B. U. T.
SERVICE BULLETINS

BRITISH RAILWAYS

SERVICE BULLETIN

MODIFICATION REQUIRED TO CONVERT AXLE
DRIVING SHAFT IN ACCORDANCE WITH LR6964

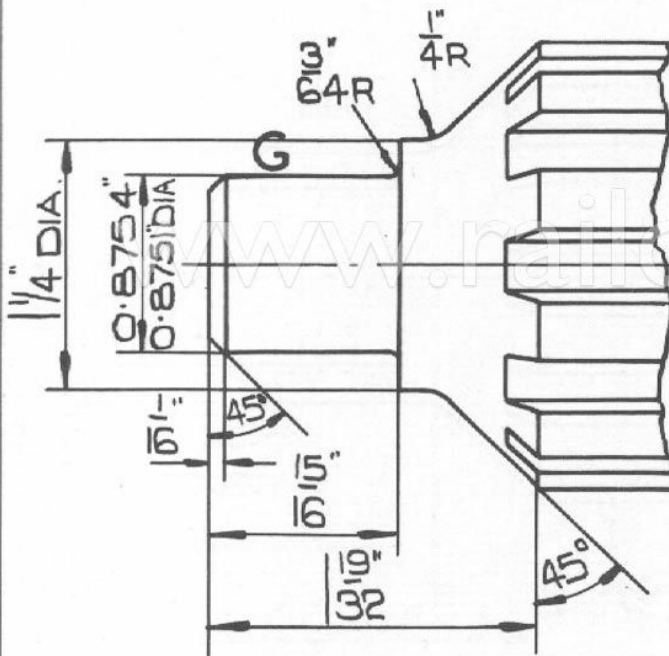
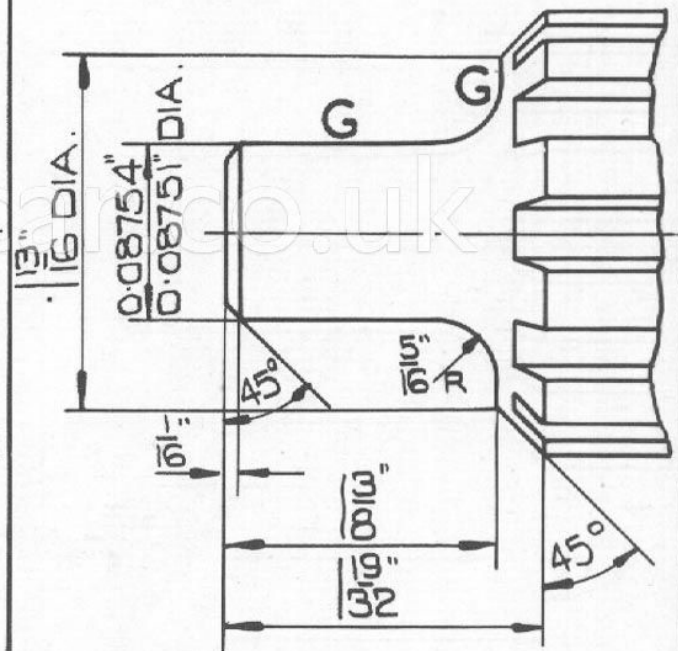
It is imperative that on the overhaul of a final drive, the driving shaft be removed and modified to the latest dimensions. This may be done by form grinding and the shaft must be magnetic tested after grinding to ensure that there are no cracks. The latest part number should be stamped on the shaft to avoid confusion.

AFTER ALTERATIONS REPLACE DISTANCE
PIECE Z7/44859 WITH ONE OF THE
FOLLOWING ALTERNATIVES Z9/44813,
Z9/44815 OR Z9/44816.

ENGINE CASING

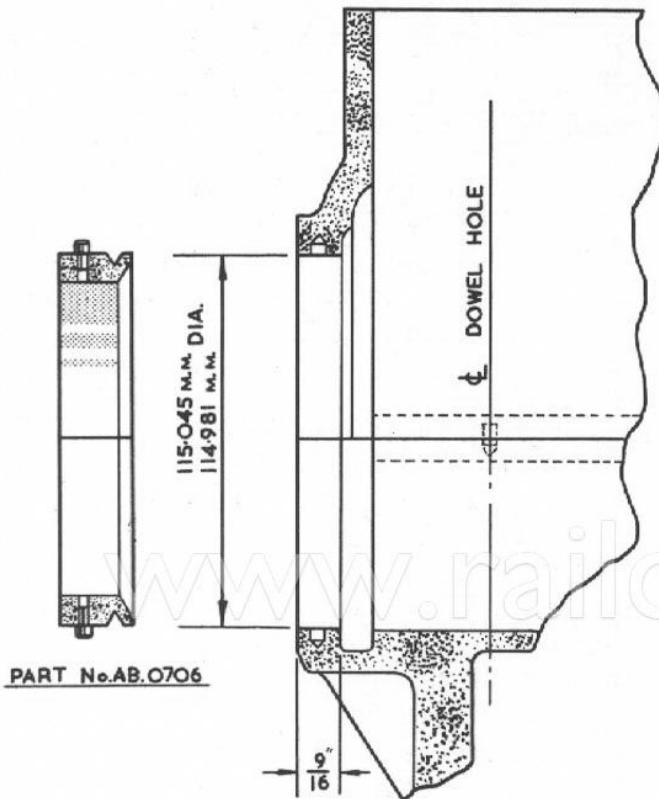
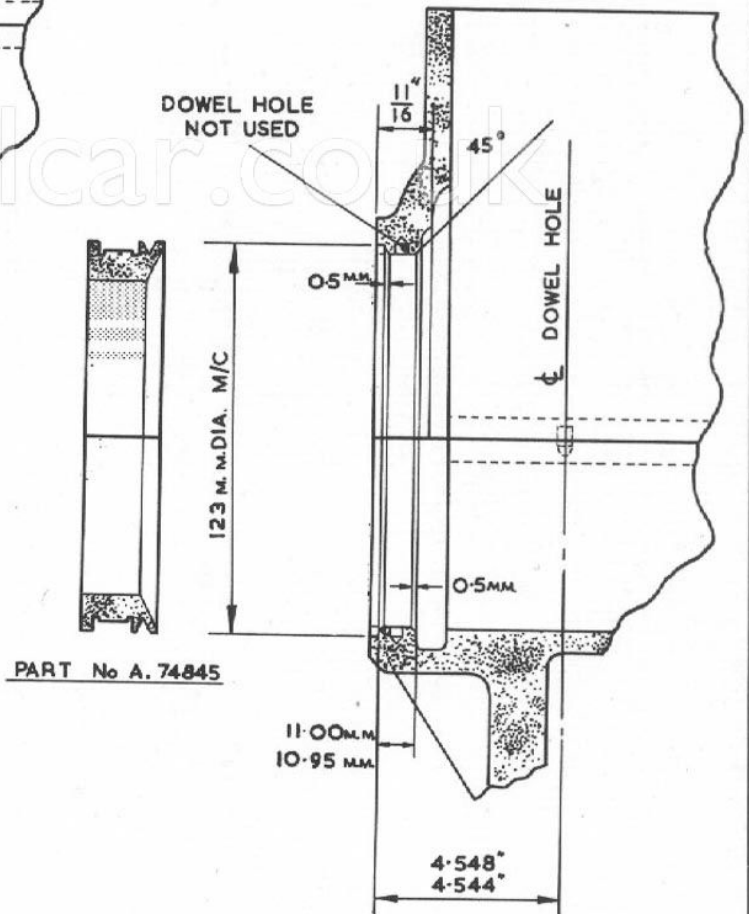
BEFORE ALTERATION

MODIFICATION TO GEARBOX FRONT
MOUNTING BRACKET.

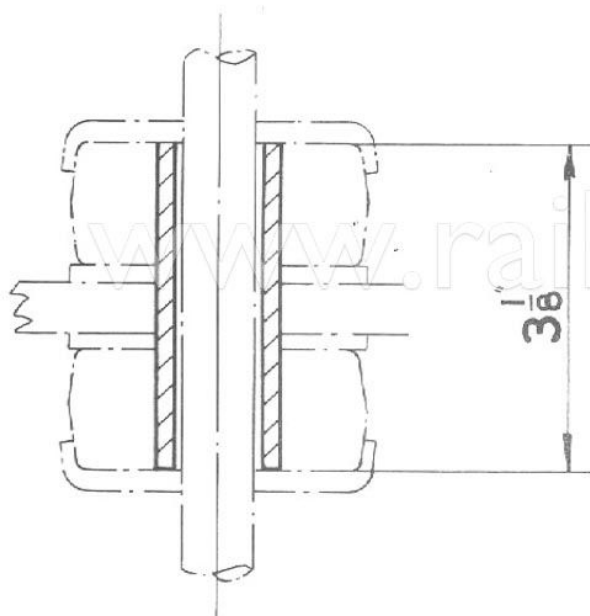
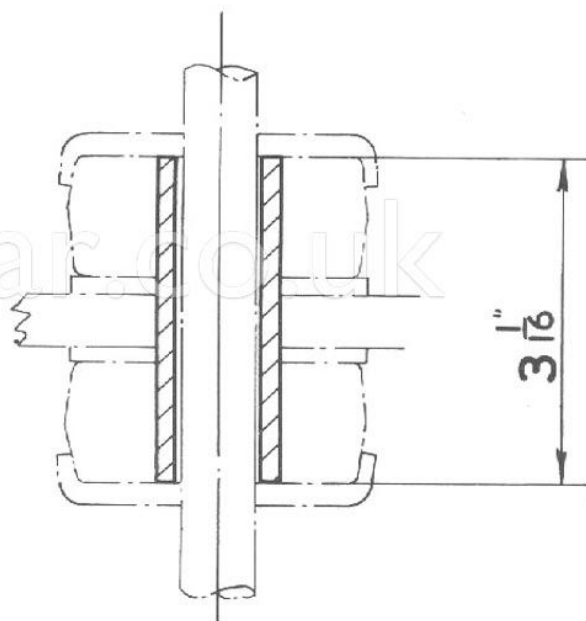
THE MODIFICATION CONSISTS OF FITTING A $3\frac{1}{16}$ " IN LIEU
OF A $3\frac{1}{8}$ " LONG FERRULE AND SHOULD BE CARRIED OUT AT
THE FIRST AVAILABLE OPPORTUNITY WHEN A GEARBOX IS
REMOVED FROM A VEHICLE AT THE MAINTAINING DEPOT
OR MAIN WORKS.

APPLICABLE TO:— ALL B.U.T. FINAL DRIVE TORQUE ARMS

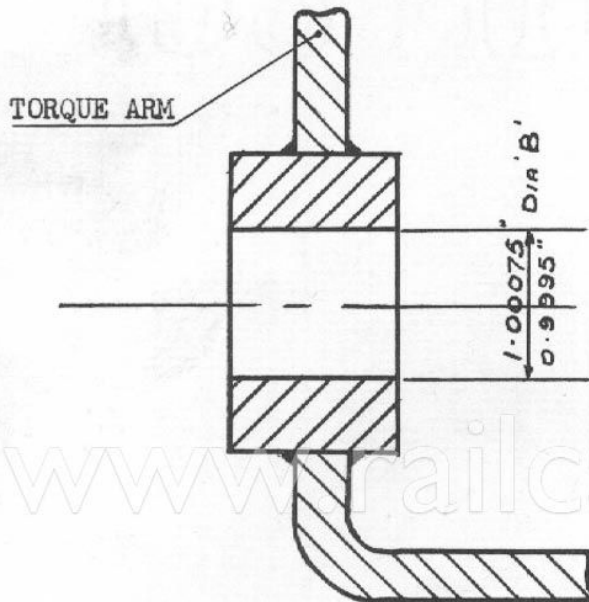
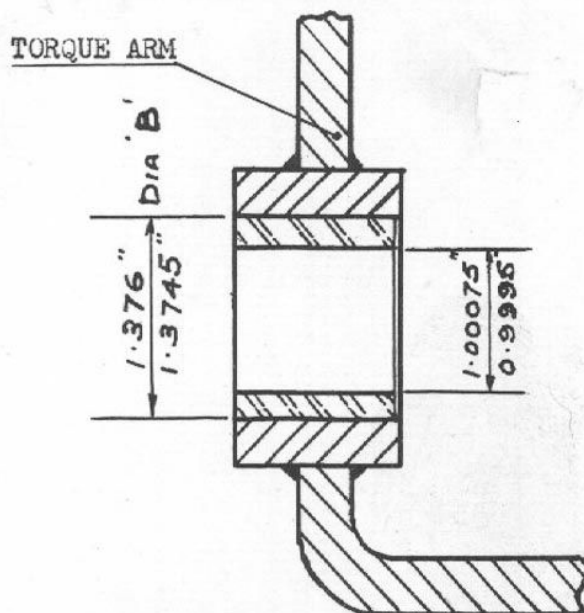
Hole in boss opened out to 1.376" - 1.3745" (Dia. "B") 1/32" chamfer x 45° added to one end.

SERVICE MOD. TO CRANKSHAFT

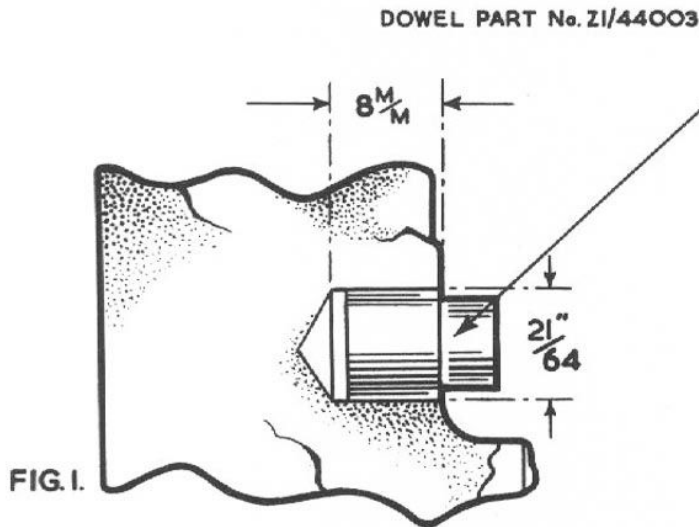
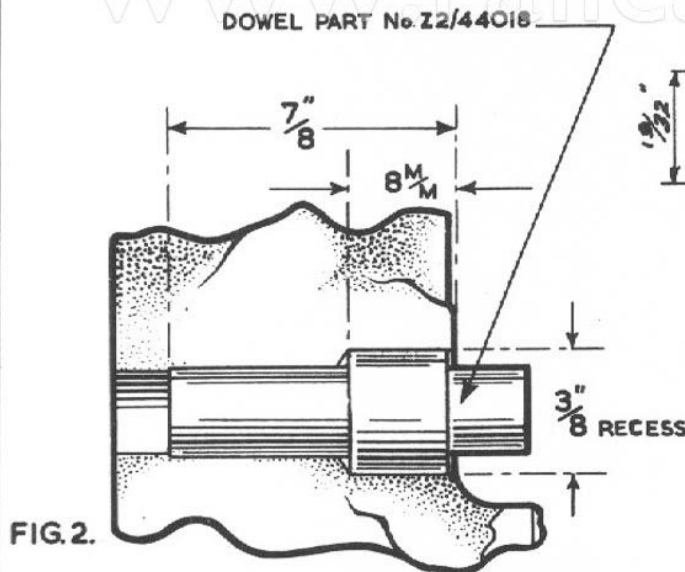
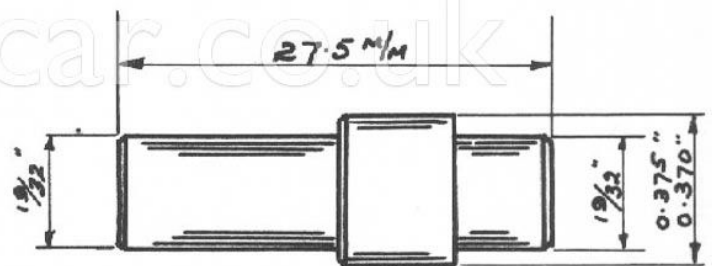
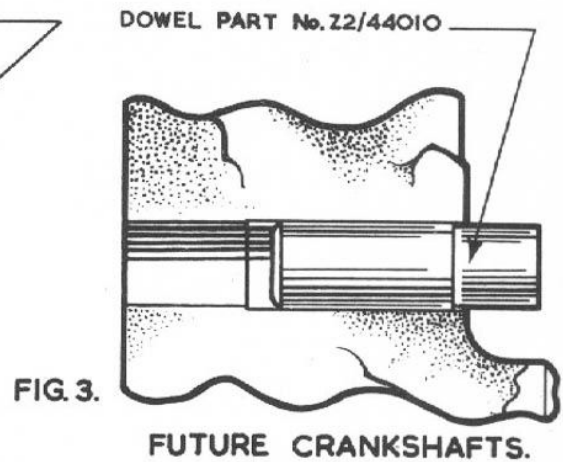
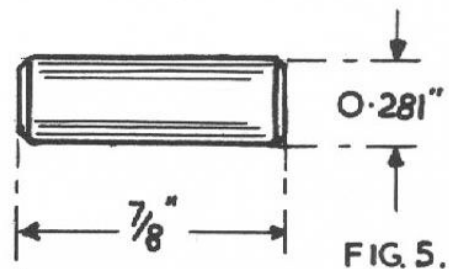
A further improvement has now been incorporated in production crankshafts by replacing the stepped dowel (Z2/44010) with a silver steel parallel dowel Part No. Z2/44021 B.R. Cat No. 9/15/30587 (See Fig. 5.) this necessitated a modification to the rear thrust ring and the old and revised Part Numbers are as follows:—

For crankshafts which have already been fitted with a service dowel or where it is desired to fit as a replacement of a dowel Z2/44010 due to elongation of the hole in the crankshaft the Part No. of the dowel to be used is Z2/44030 B.R. 9/15/44030 (See Fig. 4.) which has superseded Z2/44018.

DRILL $1\frac{1}{64}$ " RIGHT THROUGH.

RECESS $\frac{3}{8}$ " DIA. X $8\frac{1}{4}$ " DEEP.

REAM $.28175$ "-X $\frac{7}{8}$ " DEEP.

NEW DOWEL PART No. Z2/44021

FIG.2.
INTERNAL BAND.

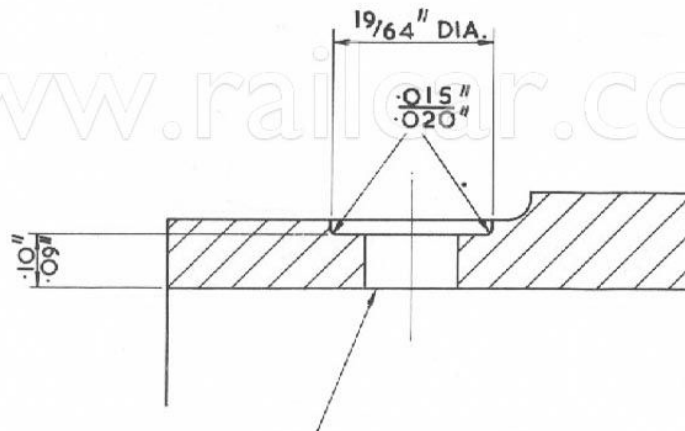
To enable fitting of moulded linings to brake bands previously fitted with the bonded-type it is necessary to modify the internal and external steel bands to provide a surface square to the rivet centre line and also bring the thickness of material riveted to within reasonably close tolerances.

The dimensional details of the modification are depicted in Fig.1 for external bands and in Fig.2 for internal bands.

ALL EXISTING RIVET HOLES
TO BE C/BORED AS SHOWN.

FIG. 2. UNIVERSAL COUPLING - CARDAN SHAFT (K6/0164 & K7/0112)

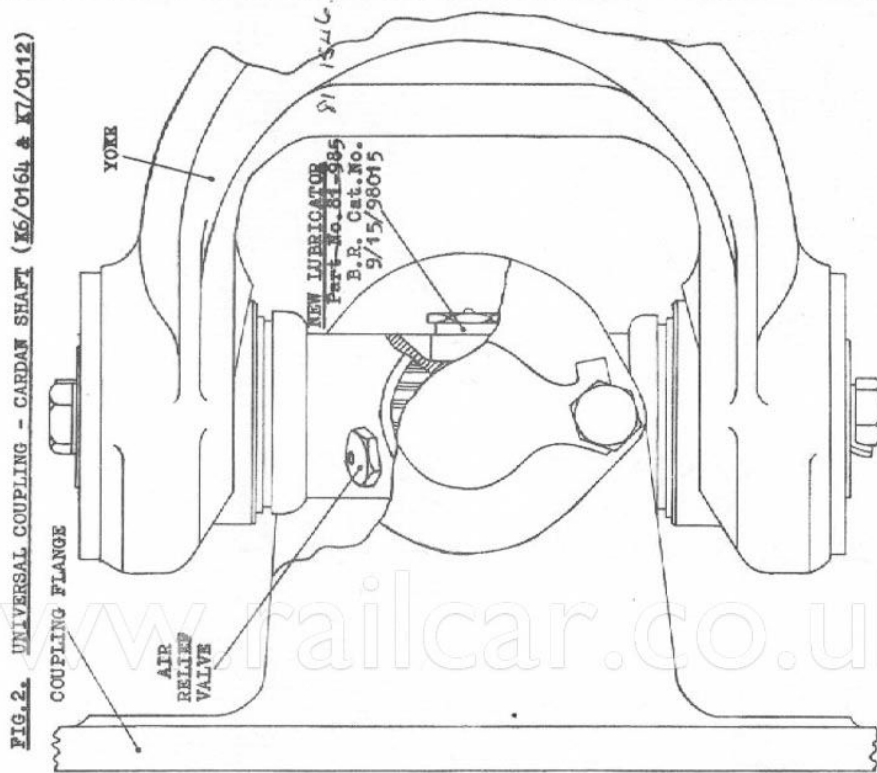
Before changing the universal coupling lubricant from oil to grease it is necessary to change the lubricator nipples. It is essential that cardan and freewheel shafts fitted with universal couplings which require replacement are modified by fitting of unit packages to bring them to the latest standard.

If the universal assembly requires replacement, unit package part number K2707 must be used, otherwise it will only be necessary to replace the existing oil nipple (Part No.81-2022: B.R.Cat.No.9/15/99043) with a grease type lubricator (Part No.81-985: B.R.Cat.No.9/15/98075) in the same position. The extension already fitted does not require changing.

REVISED CLIPPING ARRANGEMENT FOR FUEL INJECTION PIPES - A219 & A220 ENGINES.

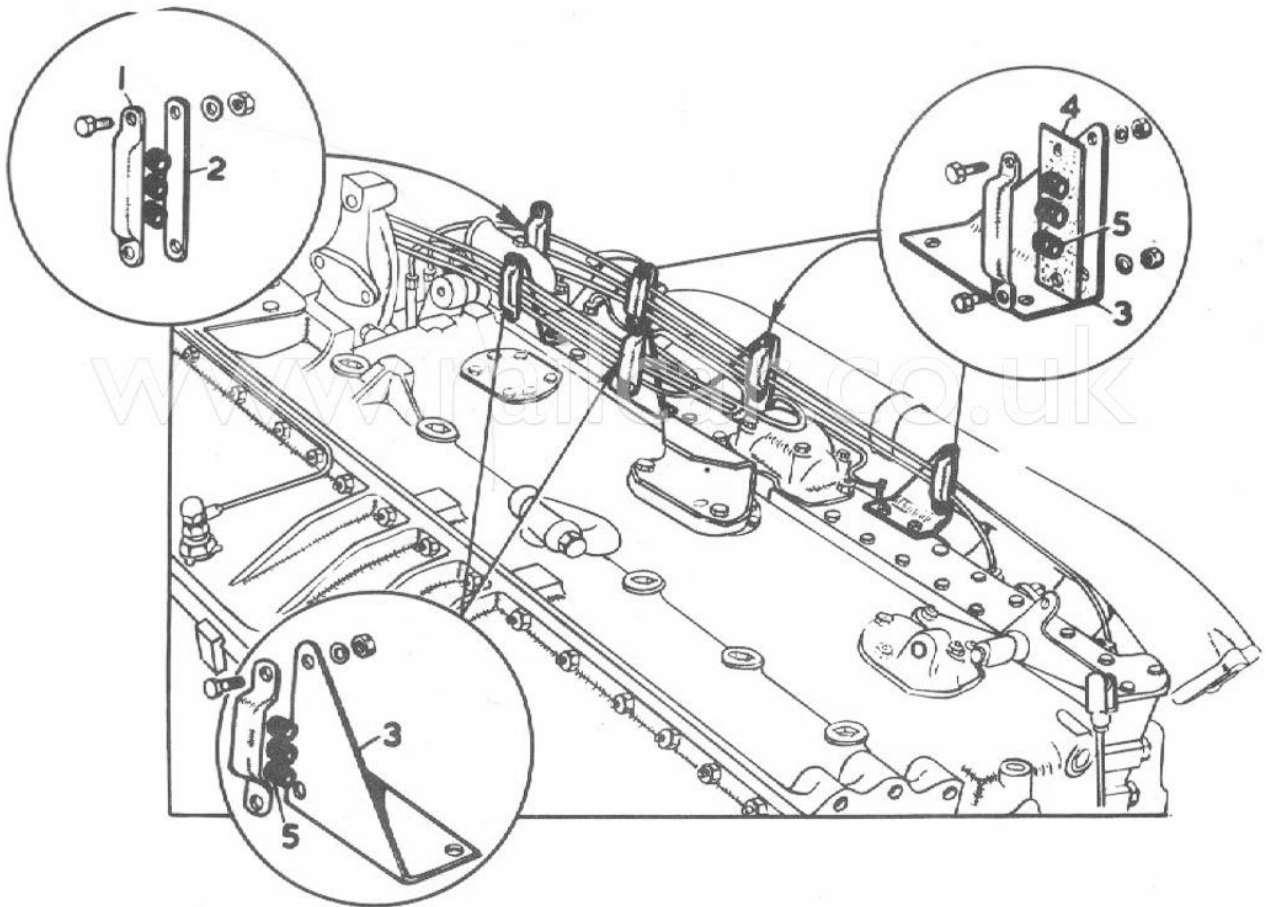
Fuel injection pipes and clips on the above engines have been modified to prevent chaffing. The alteration to the fuel injection pipes ensures greater spacing between adjacent pipes. Rubber dampers are provided for each injection pipe being retained in brackets secured to the cylinder heads.

The assembly of the brackets and clamp plate is illustrated on sheet 3. It is essential that an insulation plate (4) is fitted to the three brackets nearest the exhaust manifold in order to protect the rubber damper bushes from heat.

FIG: 2.

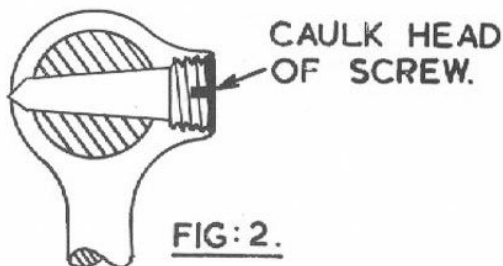
To overcome failures of the Grover lock pin (C.A.V. Part No. 7115 - 114. B.R. Cat. No. 9/75/4975) which secures the pawl to the stop spindle, the Grover lock pin is now being replaced by a solid tapered setscrew (C.A.V. Part No. 5335 - 569. B.R. Cat. No.) The existing spindle and pawl can be modified to accept the tapered setscrew and it is essential that fuel pump governors are modified when overhauled at main works.

1. Drill the boss on the pawl (C.A.V. Part No. 7023 - 937. B.R. Cat. No. 9/75/4770) using a 21 drill (0.159") and tap 5 m.m. x 0.8 (Drill through one side of the pawl only).
2. Fit pawl to spindle and using a hand taper reamer. (nominal diameter 3 m.m., 1 in 50 taper) ream hole in spindle and pawl to fit tapered setscrew. Correct fit is obtained when the underside of the screw head is approximately 0.03937" - 0.059" clear of the spindle (pawl removed) as illustrated in fig.1.
3. Assemble spindle and pawl into governor housing and fit tapered setscrew, caulk the head of the screw, fig.2 to prevent it working loose.

MACHINING REQUIRED TO EXISTING CASING

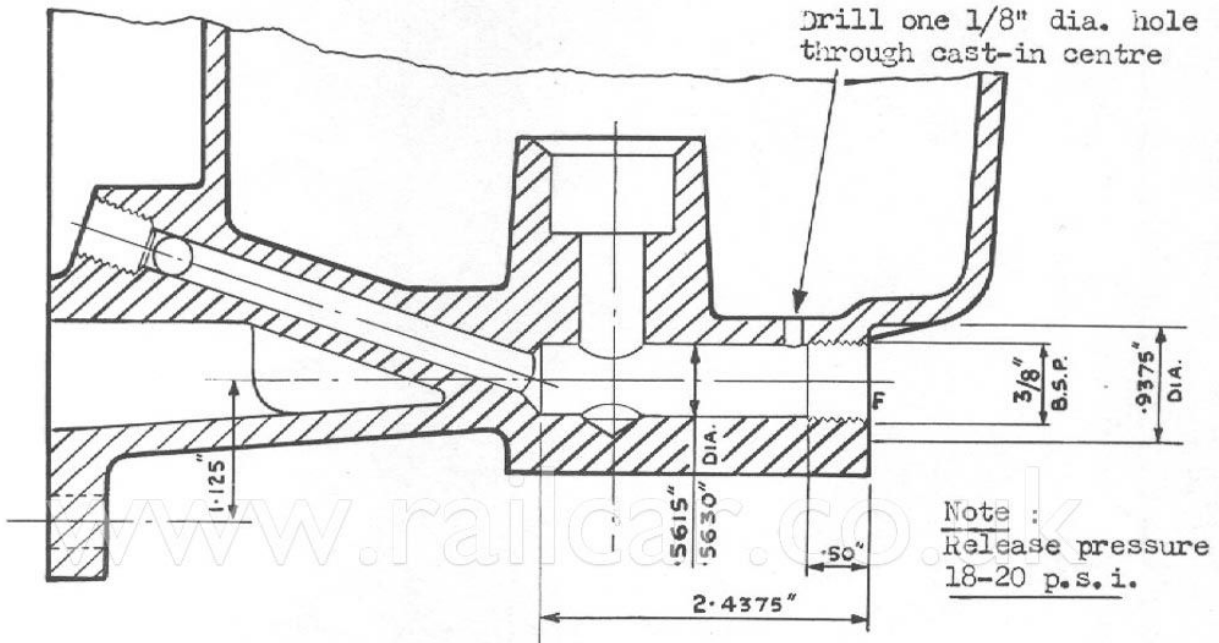
Existing filters should be modified as they pass through works for repairs as follows:—

PISTON MACHINING DETAILS

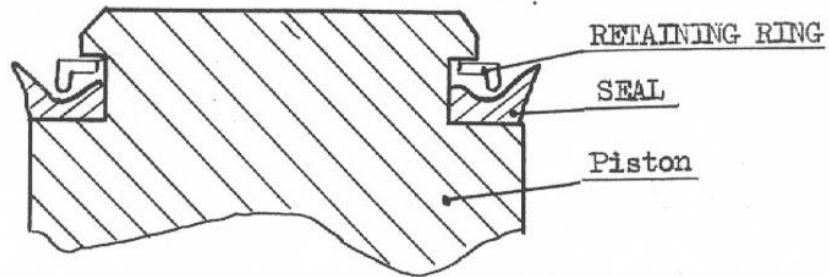
To overcome the possibility of the rubber seals on the R14 type gearbox air pistons being forced out of the ring groove, retaining rings are now being fitted to the pistons on production units (see sheet 2 fig. 1) and it is essential that all R14 gearbox pistons are modified to accept retaining rings when gearboxes are overhauled at Main Works. Any pistons in stock should also be modified.

Modification of existing pistons to accommodate the retaining rings is carried out by machining the sides of the grooves indicated 'F' in fig.2 to obtain the desired groove width tabled under dimension 'A'. In addition the diameters of the pistons must be machined to dimensions indicated on sheet 2 to enable the retaining rings to be fitted.

SCRAP SECTION SHOWING
REVISED DRILLING OF
NO3 AND 5 MAIN WEBS.

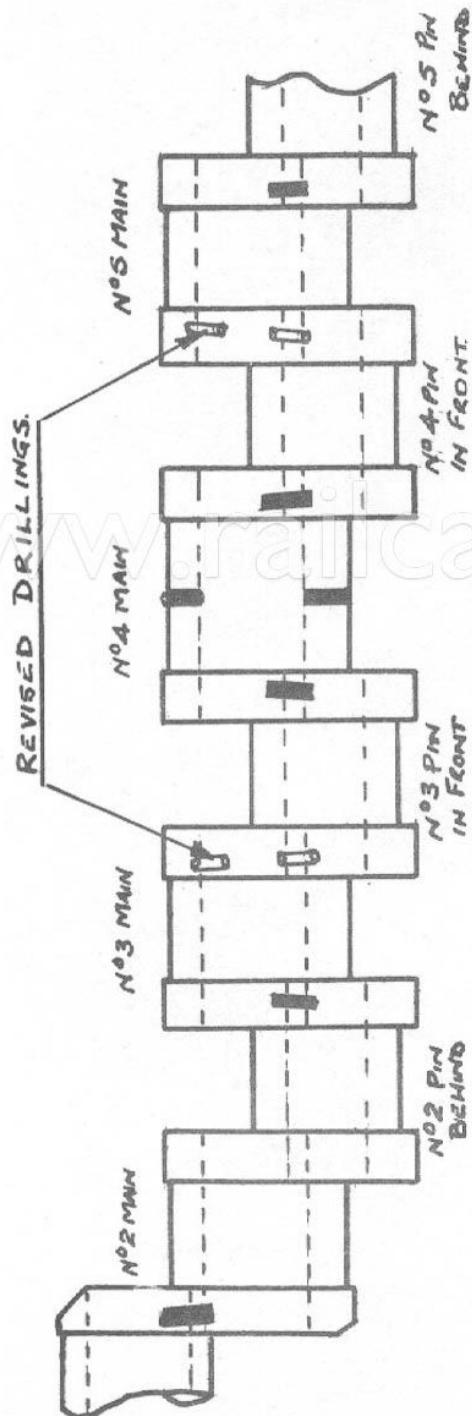
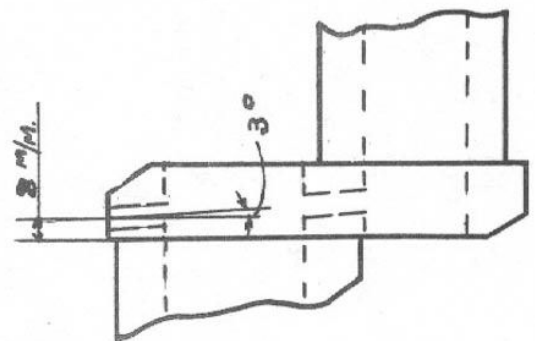
MODIFICATION TO CRANKSHAFT A14949 (HOLLW MAIN JOURNALS) FIG.1.

SCRAP SECTION SHOWING PLUGGING
EXISTING DRILLINGS N°3 AND 4 MAINS.

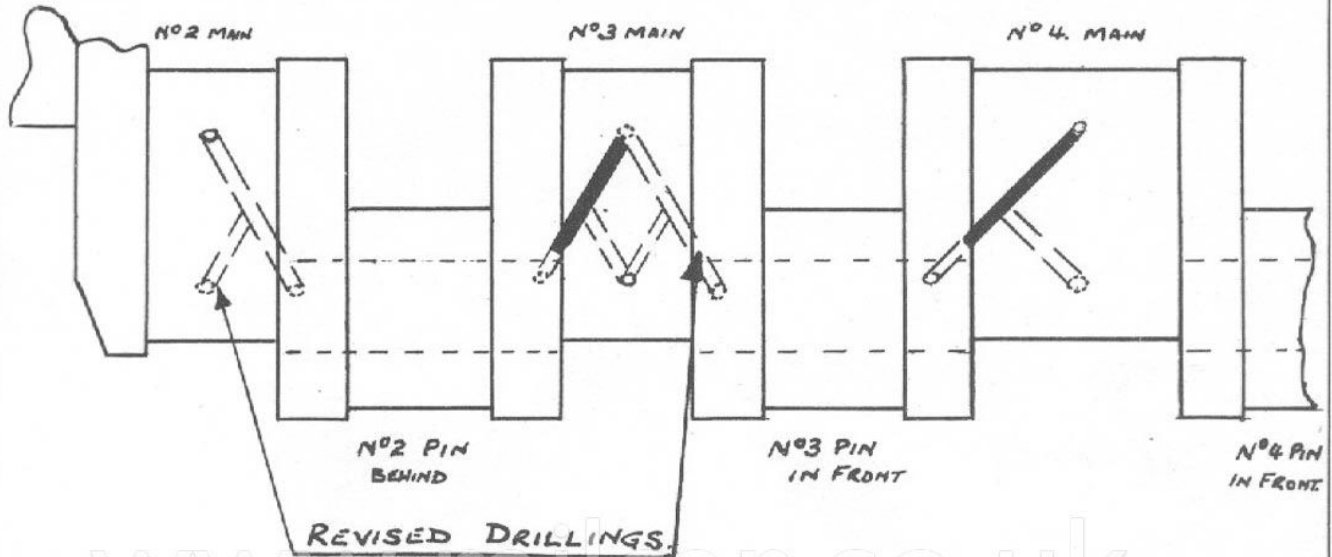
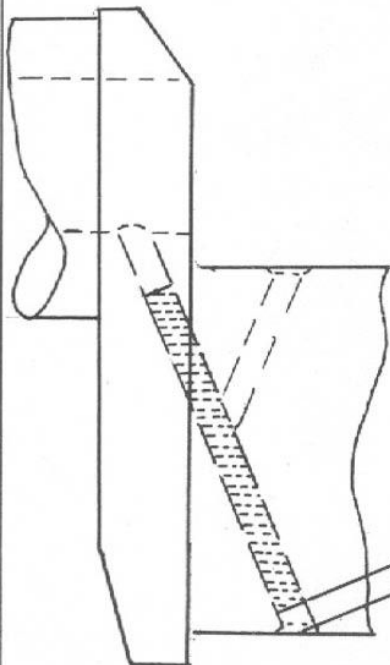
MODIFICATION TO CRANKSHAFT A14953 (SOLID JOURNALS) FIG.2.

C'BORE $\frac{5}{16}$ " DIA X $\frac{1}{4}$ " DEEP
C'S'K $\frac{1}{32}$ " ALL ROUND AT 90°
